CITY OF PORTLAND, MAINE

HISTORIC PRESERVATION BOARD

July 12, 2006

Re: Side Entry Alterations – 37 Carroll Street

TRUMPED LUMBER
37 CARROLL ST.
SIDE VIEW

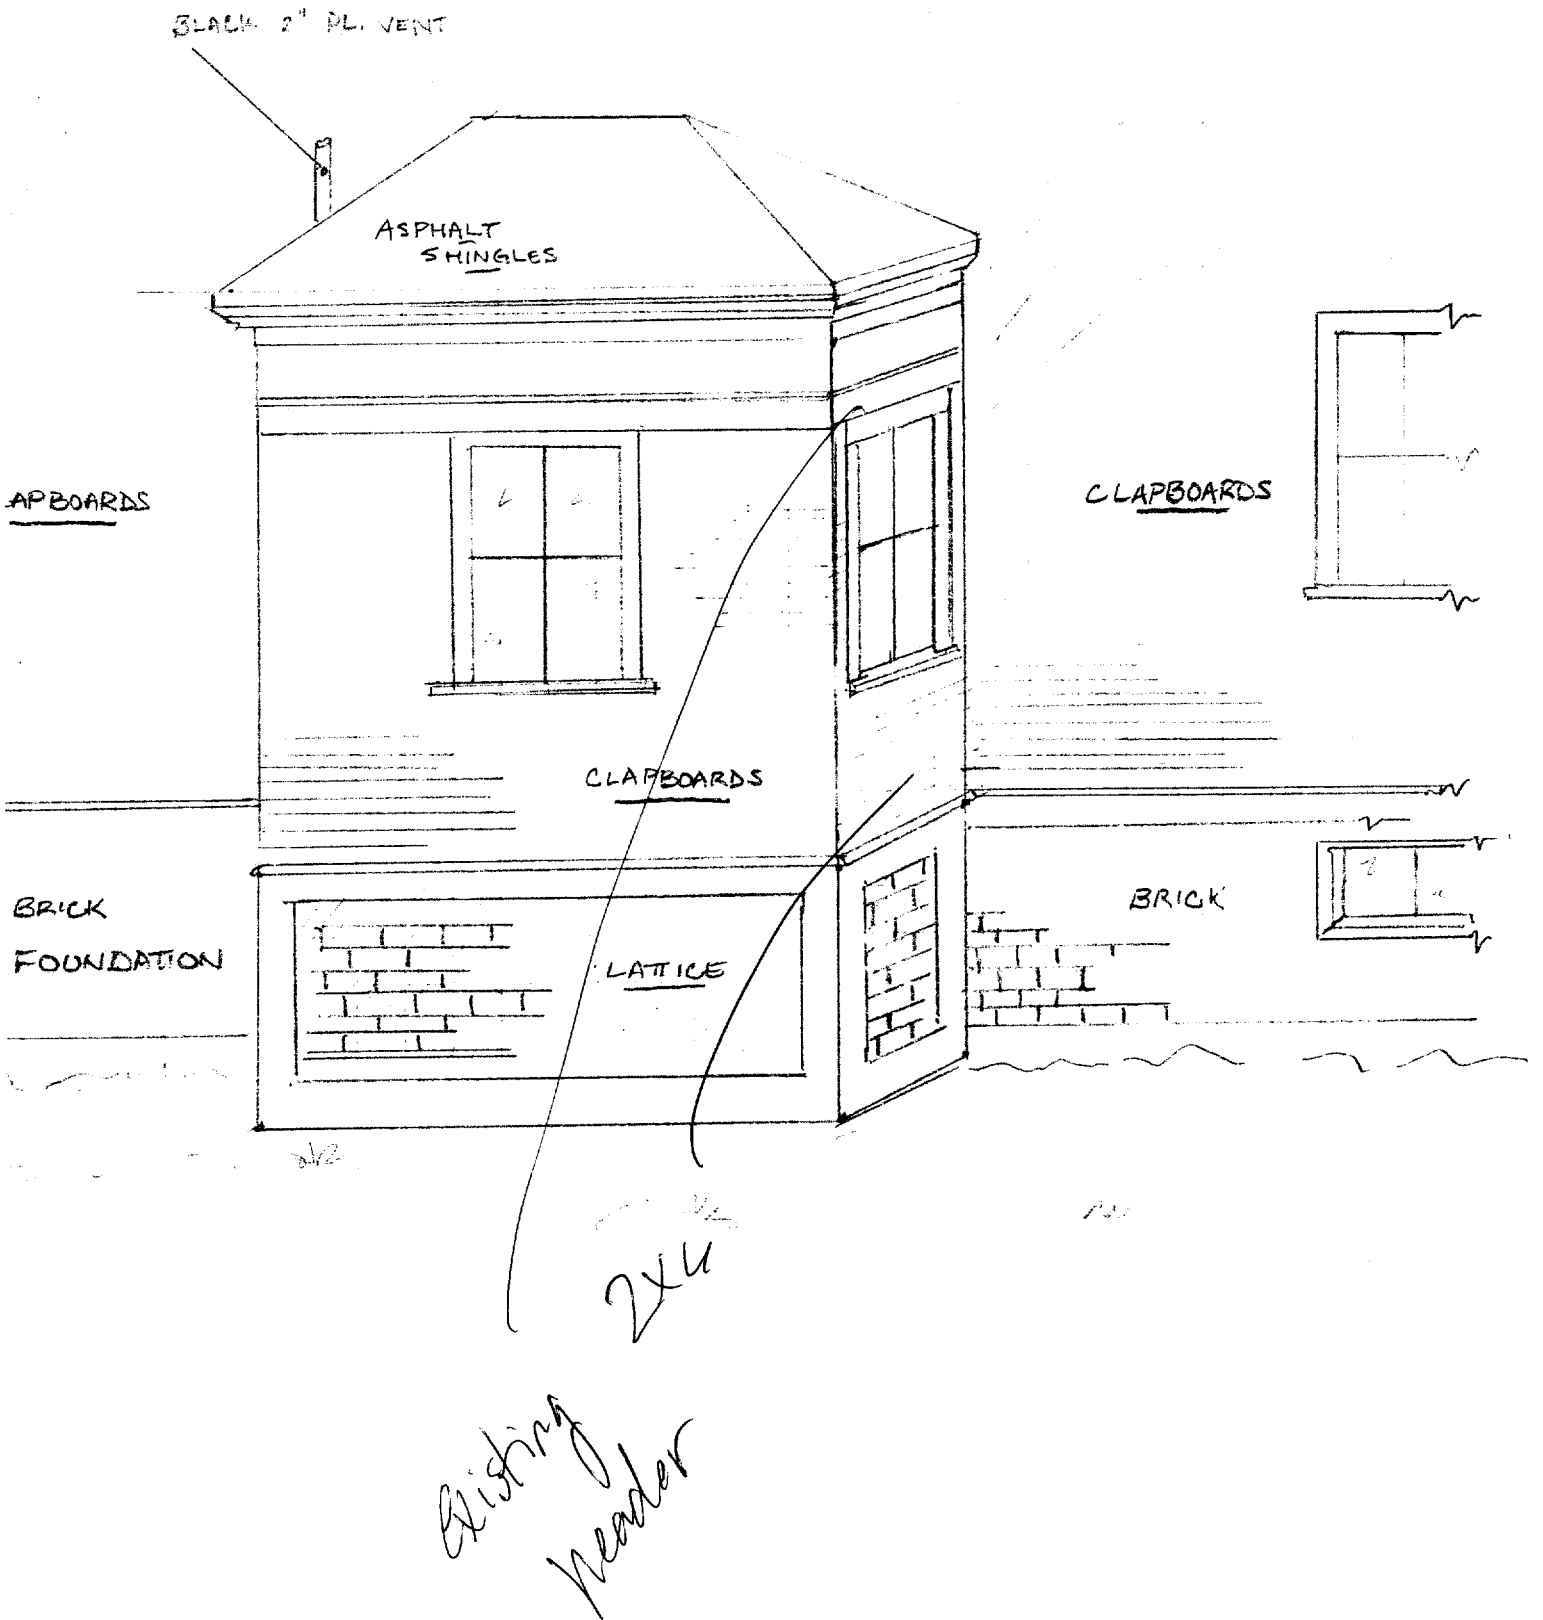
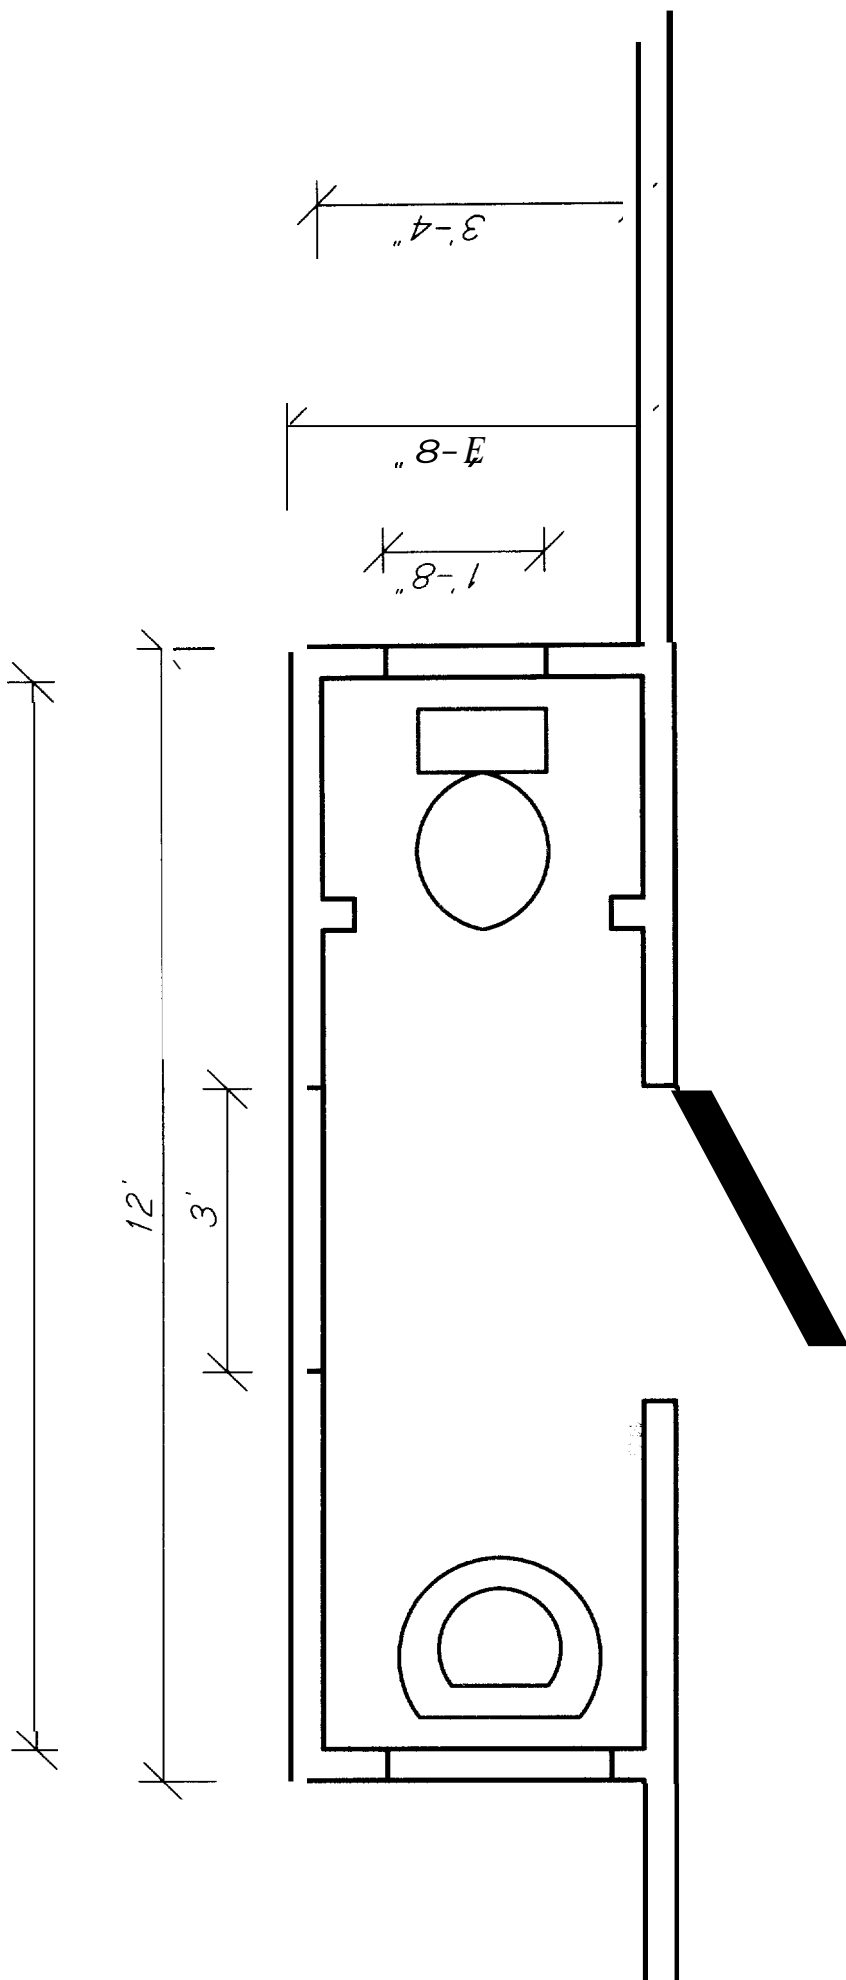
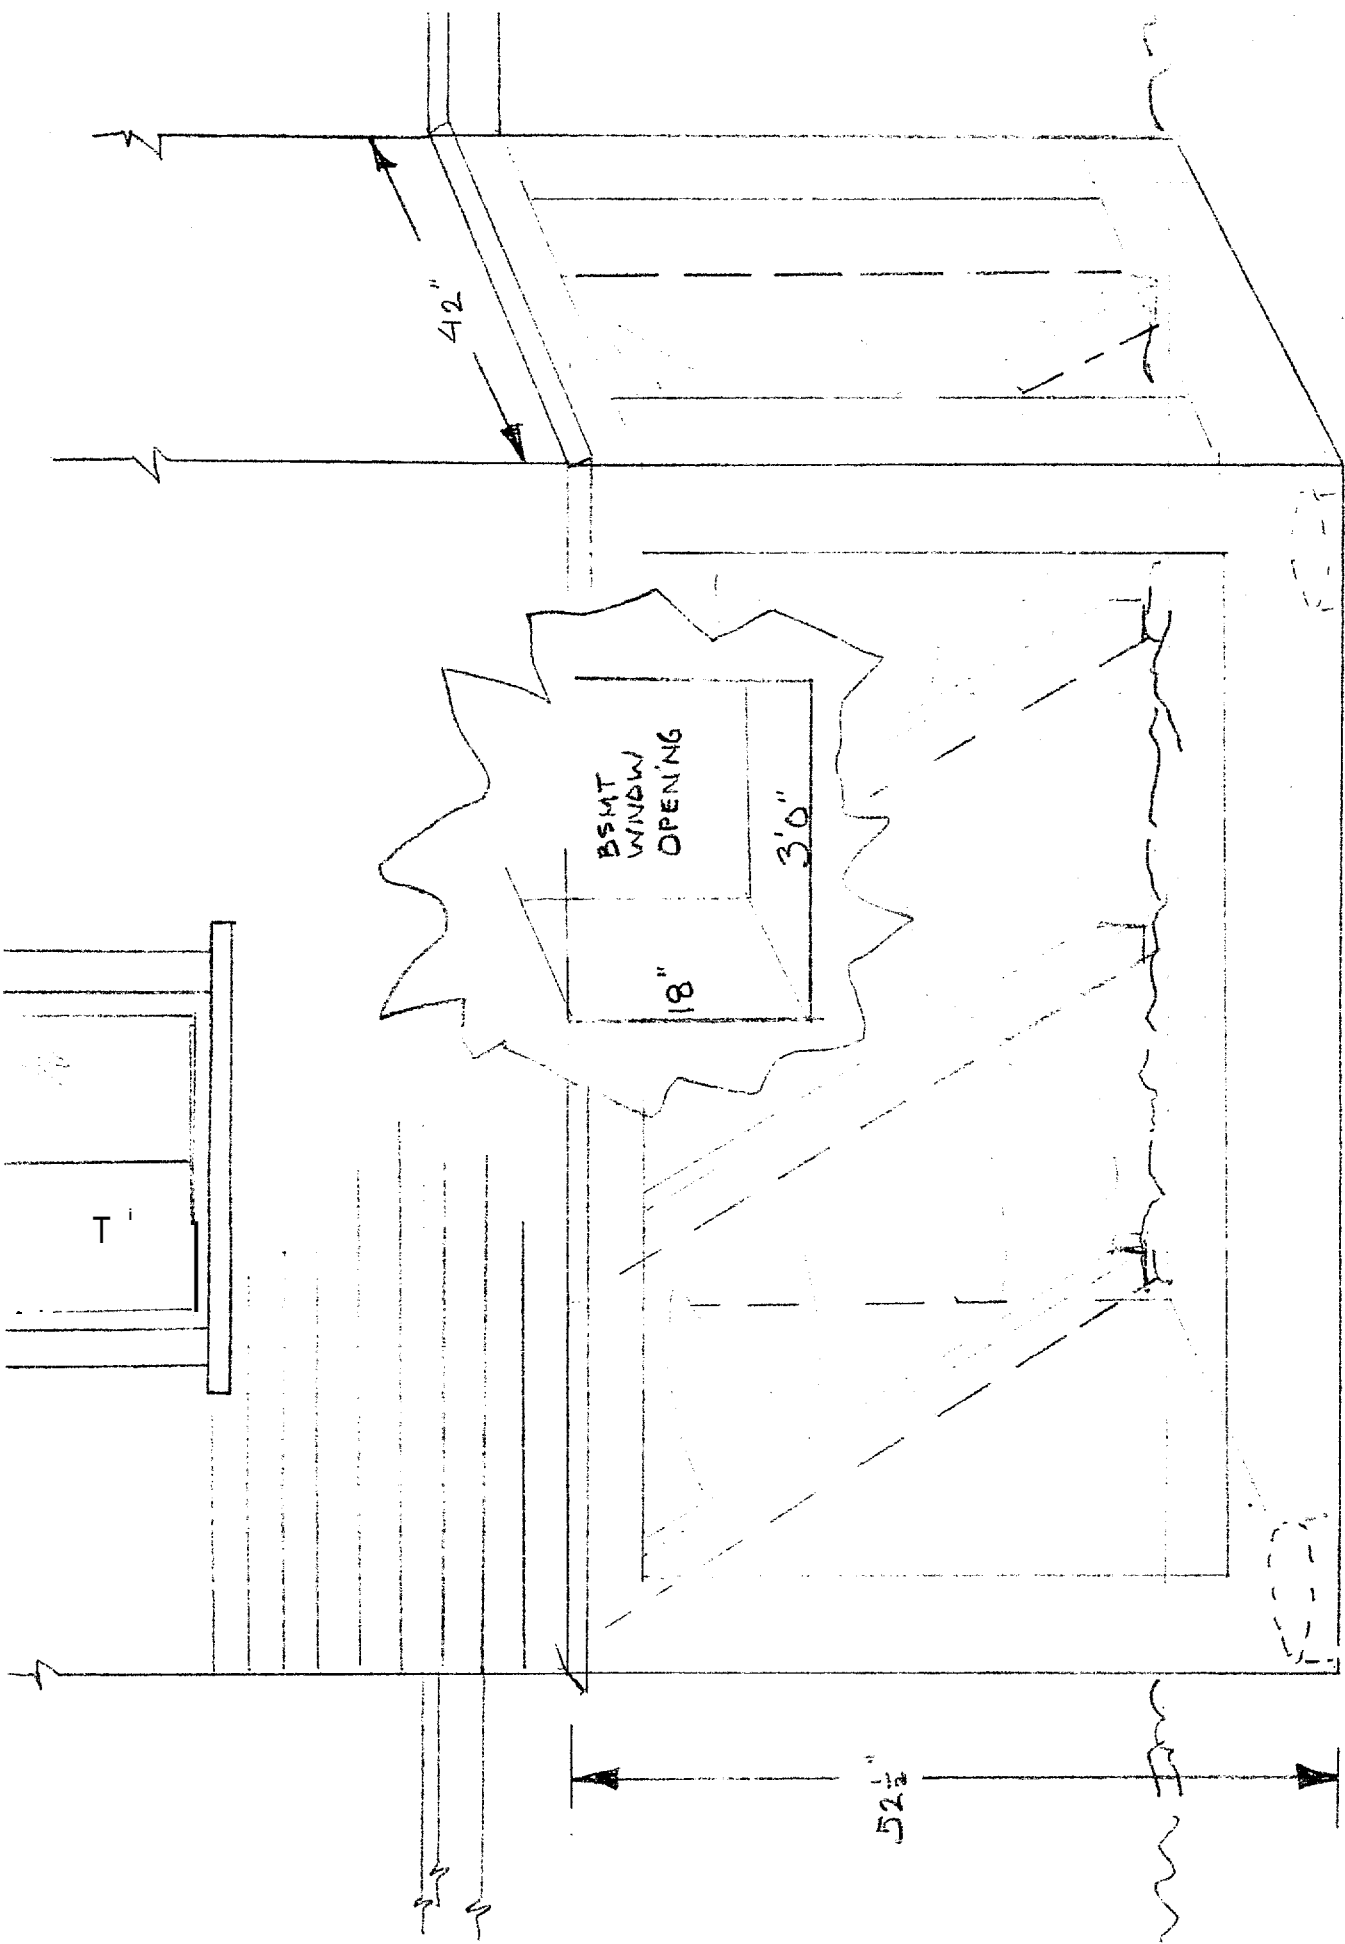
- The existing hood above the door to be removed and replaced with trim to match abutting trim detail.
- Applicant to install a window on the street-facing wall plane. Window to match the height of existing window on vestibule's west elevation; width of window to be adjusted for narrower width of front wall plane. Window to be 2/2 true divided light wood window to match existing —final window spec. to be submitted to staff for final approval. Window trim to match existing.

Note: Staff has approved your request to substitute frosted glass for clear glass in the new window.
